# Access Compliance Report

## Public Rights-of-Way

### (Curb Ramps)

Intersection ID: 51539	Main Street: TRIEG_DR	Cross Street: GLENBURN_LN	Location: S
ADA ID: CA4D4C1693D4	Ramp Type: Perp	Initial Pass/Fail: Fail	Overall Compliance: No
Severity Score: 8.75			
Codes/Mitigation Info/Possible Solution		Field Measurements/Component Compliance

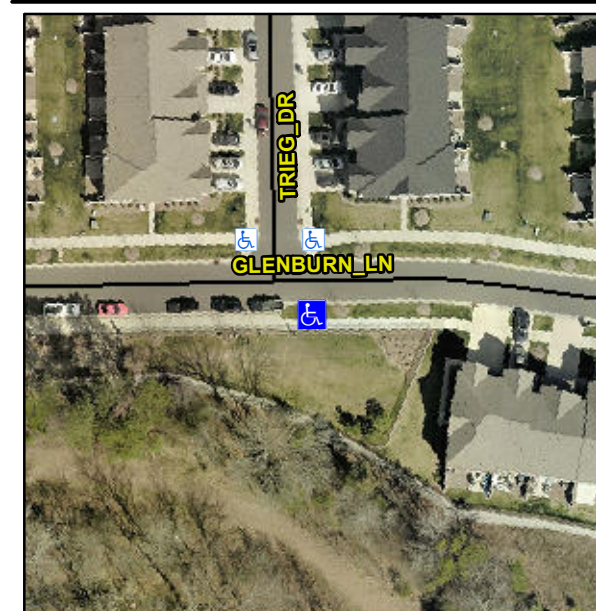
**Not Found, R304.5.1**

Compliance	Description	Data	Compliance	Description	Data
N/A	Ramp Length (in)	91.0	Yes	Ramp Slope (%)	5.6
No	Ramp Width (in)	46.5	Yes	Ramp XSlope (%)	0.7
N/A	Flare Type LT	N/A	N/A	Flare Type RT	N/A
N/A	Flare Slope LT (%)	N/A	N/A	Flare Slope RT (%)	N/A
N/A	Flare Traversable LT?	N/A	N/A	Flare Traversable RT?	N/A
N/A	Landing Length (in)	N/A	N/A	DWS Provided?	N/A
N/A	Landing Width (in)	N/A	N/A	DWS Contrast?	N/A
N/A	Landing Slope (%)	N/A	N/A	DWS Length (in)	N/A
N/A	Landing X Slope (%)	N/A	N/A	DWS Full Width?	N/A
N/A	Landing Curb? (Y/N)	N/A	N/A	DWS Offset (in)	N/A
N/A	Shared Landing?	N/A			
N/A	Gutter Ponding?	N/A	N/A	Gutter Slope (%)	N/A
N/A	Gutter Lip Ht (in)	N/A	N/A	Gutter X Slope (%)	N/A
N/A	Painted X Walk1?	No	N/A	Painted X Walk2?	N/A
	X Walk 1 Direction	To N		X Walk 2 Direction	N/A
N/A	X Walk 1 Width (in)	N/A	N/A	X Walk 2 Width (in)	N/A
	X Walk 1 Slope (%)	2.5		X Walk 2 Slope (%)	N/A
	X Walk 1 X Slope (%)	1.2		X Walk 2 X Slope (%)	N/A

**Remove & Replace Entire Ramp.**
